Models **36,41**

Silencer complete

5:X 92.125-26a 3.46 03-93

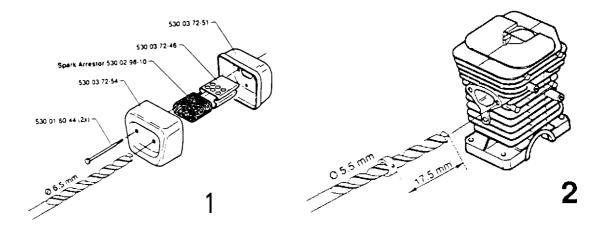
We have introduced a silencer bolt with a diameter of 6 mm from serial number 2390902. The old one was 5 mm.

- **Remark:** 1 = Replaced parts are excluded as spare parts. When using old parts and a new bolt 530 01 60-44, the two holes must be adjusted. Use a drill with a diameter of 6,5 mm. (See illustration).
 - 2 = Replaced parts are excluded as spare parts. When using old cylinders and a new bolt, 530 0160-44, the two holes must be made bigger. Use a drill with a diameter 5,5 mm and drill to a depth of 17,5 mm (See illustration).
 - * = When using a new bolt, a new flame protector must be used.
